Published by:
Service Department BG Audio

SERVICE NEWSLETTER

MOUNTING OF BRACKET

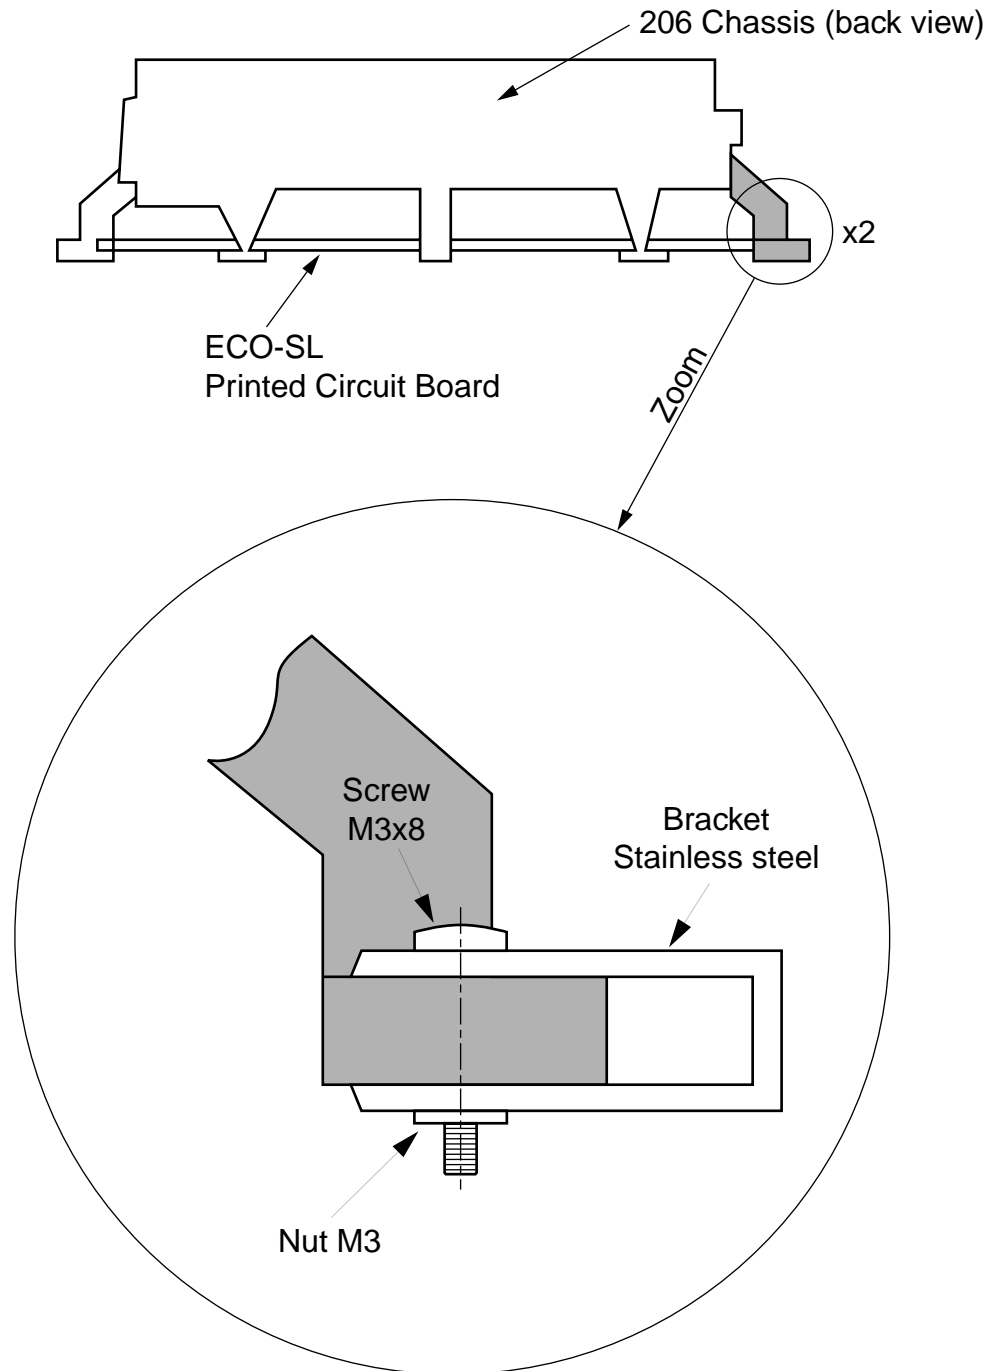
SYMPTOM : The CD drawer does not open or close.

CURE : The ECO Short Loader is out of position at the rear fixing slot. This fault might be caused when the set has been dropped.

Add brackets to the rib at both sides of the ECO Short Loader Chassis (item 206).

4822 420 10641 Bracket
4822 502 11473 Screw M3x8
4822 505 10758 Nut M3

Mount the bracket with screw and nut as shown in the drawing on next page.

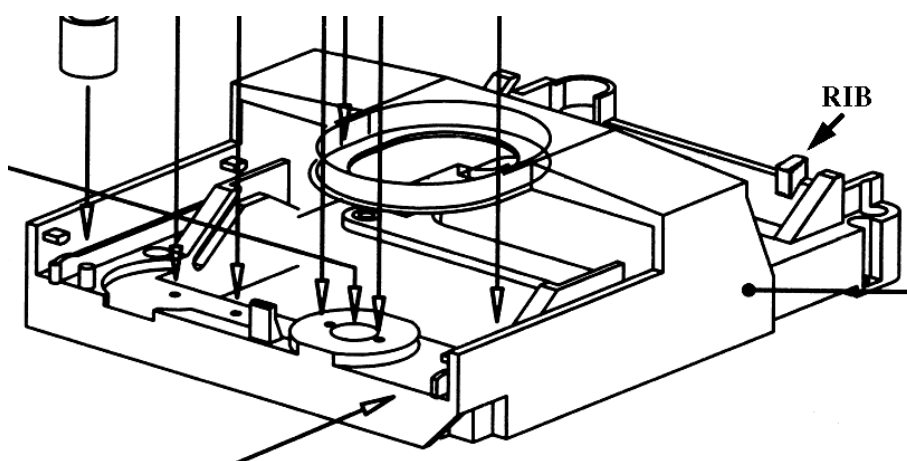
SYMPTOM : Defective mainstransformer.

CURE : This fault is caused by the thermal fuse.
Solution:
New transformer has been implemented in production;
The old transformer was marked "NC-I1887TM"
The new transformer is marked "NC-I1887TM1"
(remark: "1" is added).
The transformer is available via service code 4822 146 31476.

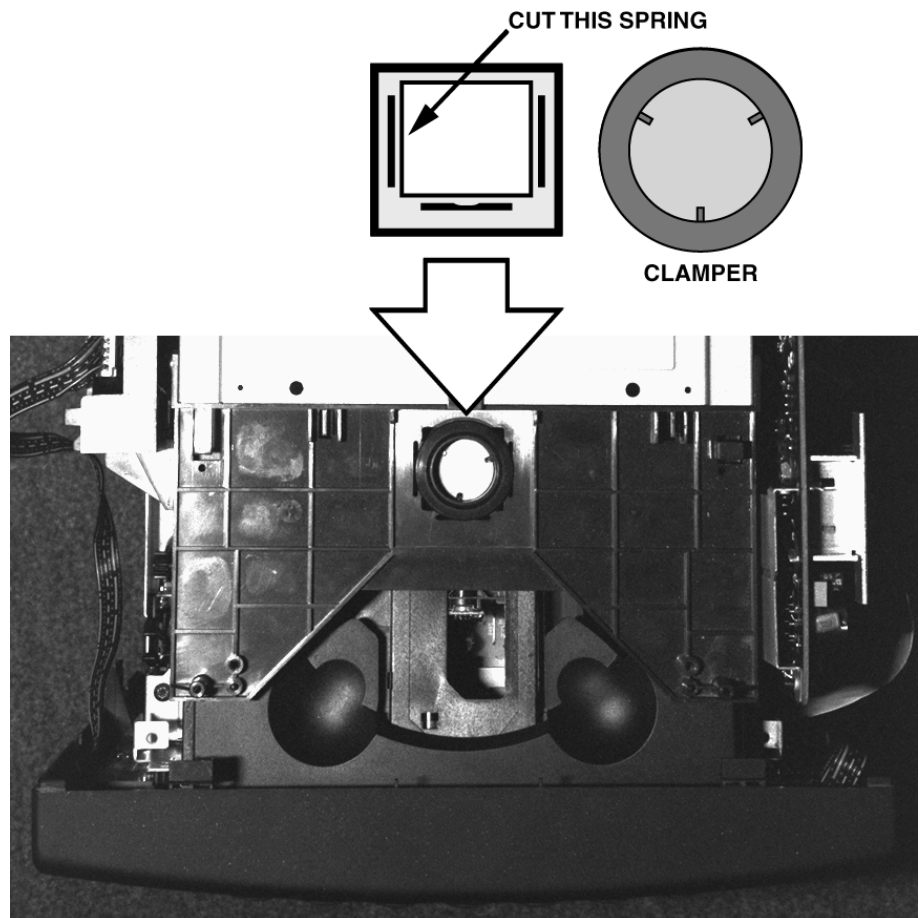
INFORMATION : **Service manual**
Item 212 of Short loader is incorrectly coded.
Service codenumber should read 4822 402 61412 instead of 4822 691 61412.

CONTROL/CD-PART – COPPERSIDE VIEW

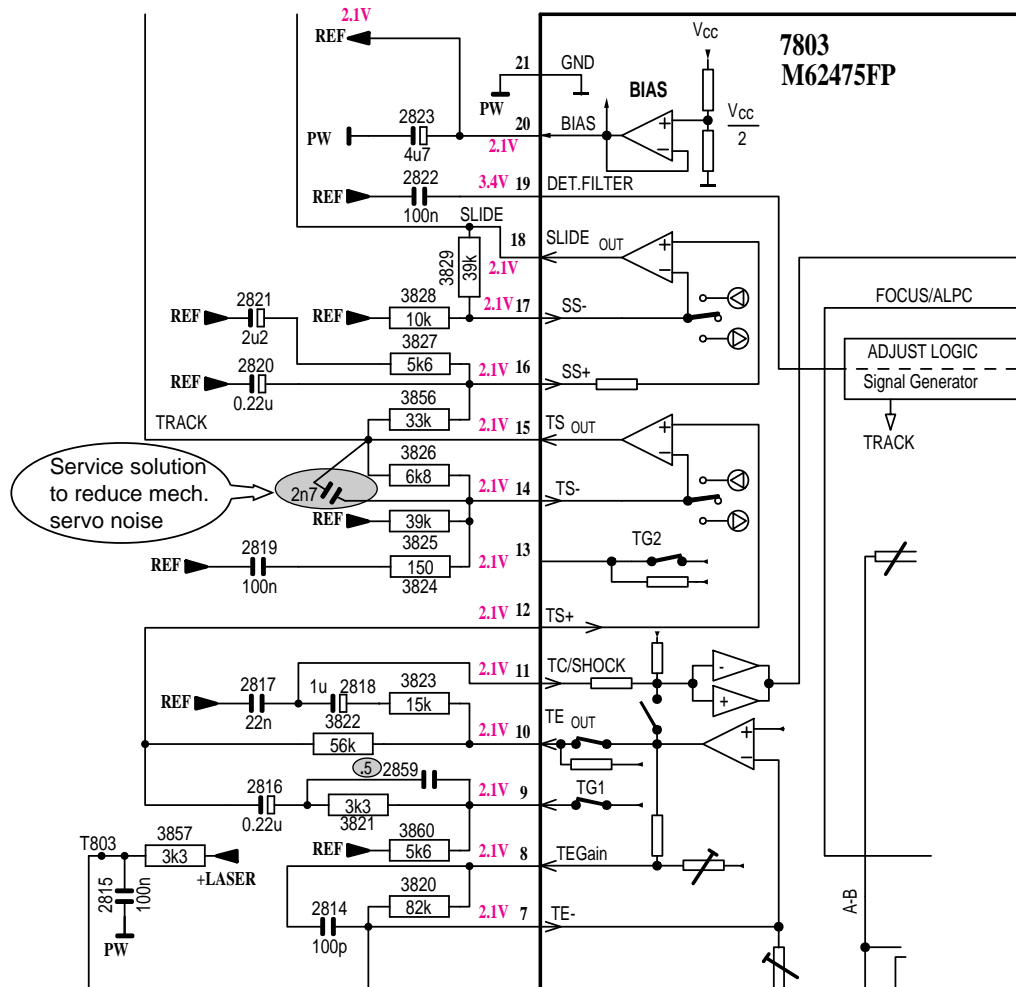
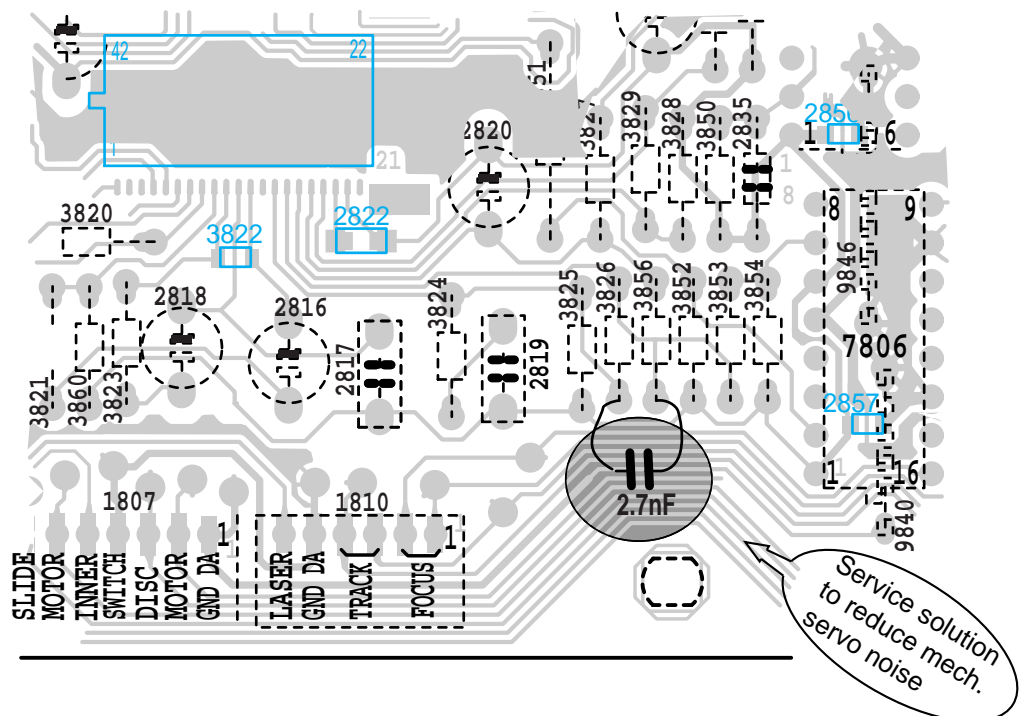
SYMPTOM : The set give a whistling sound when playing a disc.
It sounds like mechanical oscillation.

CURE : Fault is caused by a peak in the gain response curve of the track servo amplifier at about 15kHz. This is far above the bandwidth of 1.5kHz. This does not influence the behaviour of the track servo itself, but causes mechanical noise produced by the pick-up.
The lay-out of combi board has been modified.
With the modified board C2859 and C2858 have been added and the mechanical noise has been reduced by 5dB.

Service solution for sets without modified boards:
Add a capacitor of 2.7nF in parallel to R3826 (4822 126 12148).

Referring to next Figure. Part of schematic and layout drawing.

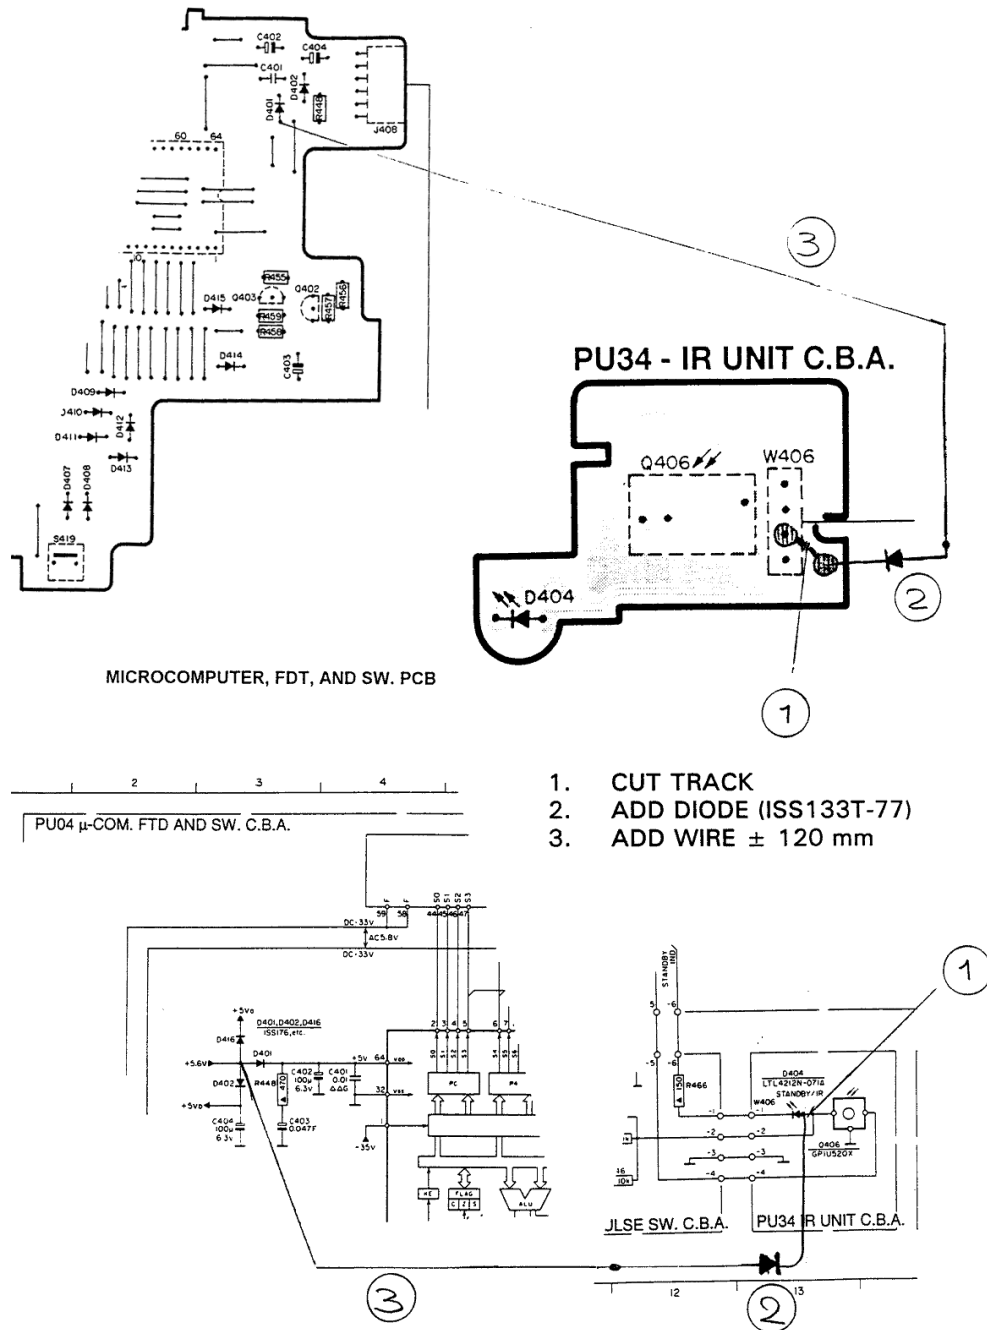
SYMPTOM : Remote control does not activate the volume knob at temperatures below 7°C.

CURE : Cause:
The supply voltage of the IR-eye is not clean, but has a ripple of about 250mV peak-to-peak during IR reception. This ripple is caused by the blinking standby LED during IR reception due to a shared supply line.

1. Cut PC Board track between D404 and Q406
2. Add diode 1SS133T-77 (4822 130 33305)
3. Add wire (~120mm) between junction D401/D402 to D404 positive

1. CUT TRACK
2. ADD DIODE (ISS133T-77)
3. ADD WIRE ± 120 mm

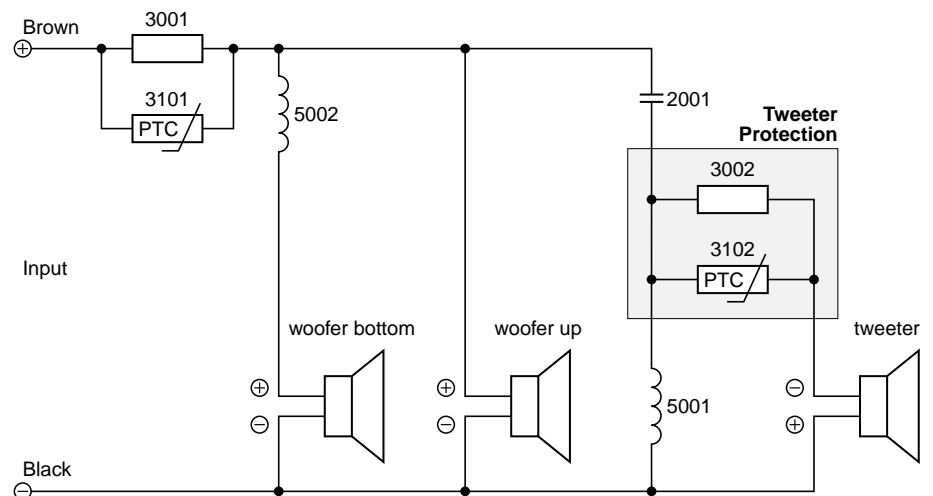
INFORMATION : **Service hints:**
 For loudspeakerbox produced before week 9545 and brought in for repair of a defective tweeter AD11401/T6 (4822 240 70223), it is necessary to add a tweeter protection circuit in the wire to the tweeter.
 See next drawings or service information A95-101 (4822 725 24783).

The extra components used are:
 R = resistor 5.6Ω 5Watt (4822 053 32568)
 PTC = PTC RXE040 (4822 116 40264)
